## Issue List

## Homesense Uptown Boca (Boca Raton, FL)

### Project Issue Information

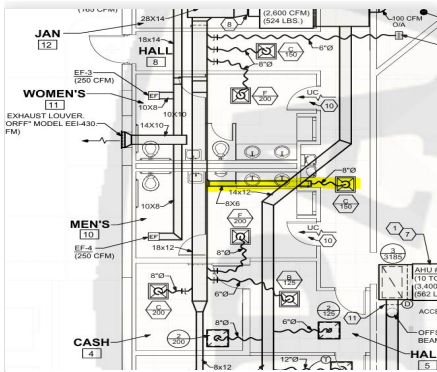
**Issue Name :** AHU-1 Flex Duct Issues - Manager's Office  
**Description :** The flex duct is folded at 90 degree angles and therefore restrictive leading to both supply diffusers in the Manager's Office (Room 3). As a result these diffusers are at 119CFM and 162CFM out of 225CFM design.  
**Created By :** National TAB                      **Assigned To :** National TAB - Stephen Tassinaro  
**Status :** Open  
**Priority :** Urgent                                      **Asset Tag :**  
**Originated Date :** 12/05/2024 - Stephen Tassinaro - National TAB

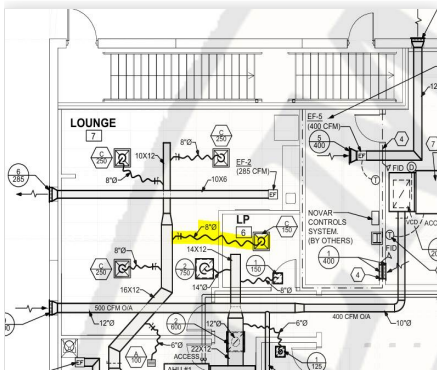
**Issue Name :** AHU-1 Hallway Diffuser Damper Not Located  
**Description :** No balancing damper could be located for the supply diffuser in the Hallway (Room 8). As a result the airflow is currently 284CFM out of 150CFM design.  
**Created By :** National TAB **Assigned To :** National TAB - Stephen Tassinaro  
**Status :** Open  
**Priority :** **Urgent** **Asset Tag :**  
**Originated Date :** 12/05/2024 - Stephen Tassinaro - National TAB

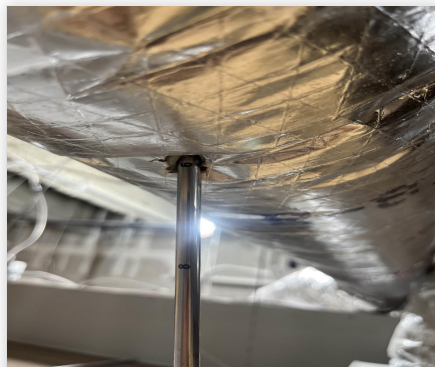
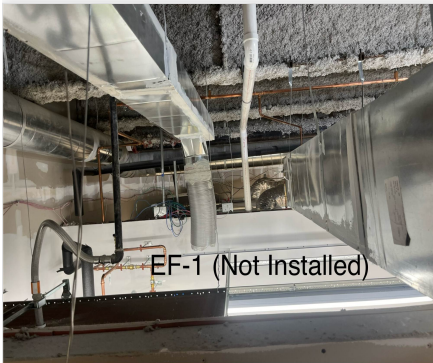
**Issue Name :** AHU-1 Room 6 Supply Duct Undersized  
**Description :** The currently installed supply duct in Room 6 (LP) is 6" diameter and outputting 98CFM out of 150CFM design. The mechanical plans call for an 8" duct to be ran to this room.  
**Created By :** National TAB                      **Assigned To :** National TAB - Stephen Tassinaro  
**Status :** Open  
**Priority :** **Urgent**                                      **Asset Tag :**  
**Originated Date :** 12/05/2024 - Stephen Tassinaro - National TAB

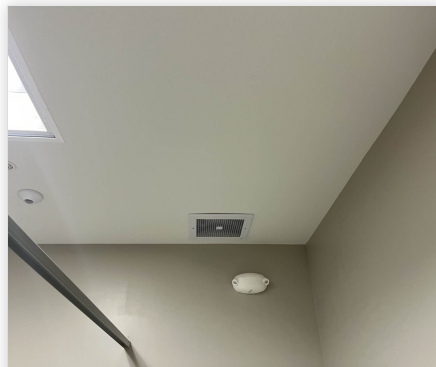
**Issue Name :** EF-1 Not Installed  
**Description :** Ceiling mount exhaust fan is not installed at this time.  
**Created By :** National TAB                      **Assigned To :** National TAB - Stephen Tassinaro  
**Status :** Open  
**Priority :** Urgent                                      **Asset Tag :**  
**Originated Date :** 12/05/2024 - Stephen Tassinaro - National TAB

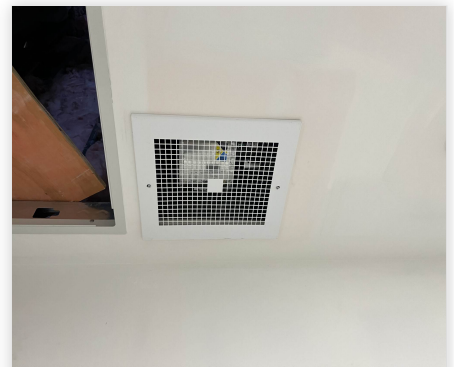
**Issue Name :** EF-2, EF-3, and EF-4 Not Running  
**Description :** Ceiling mount exhaust fans 2, 3, and 4 are not running at this time. The electrician stated there was an RFI and he is waiting on 120v transformers.  
**Created By :** National TAB                      **Assigned To :** National TAB - Stephen Tassinaro  
**Status :** Open  
**Priority :** Urgent                                      **Asset Tag :**  
**Originated Date :** 12/05/2024 - Stephen Tassinaro - National TAB
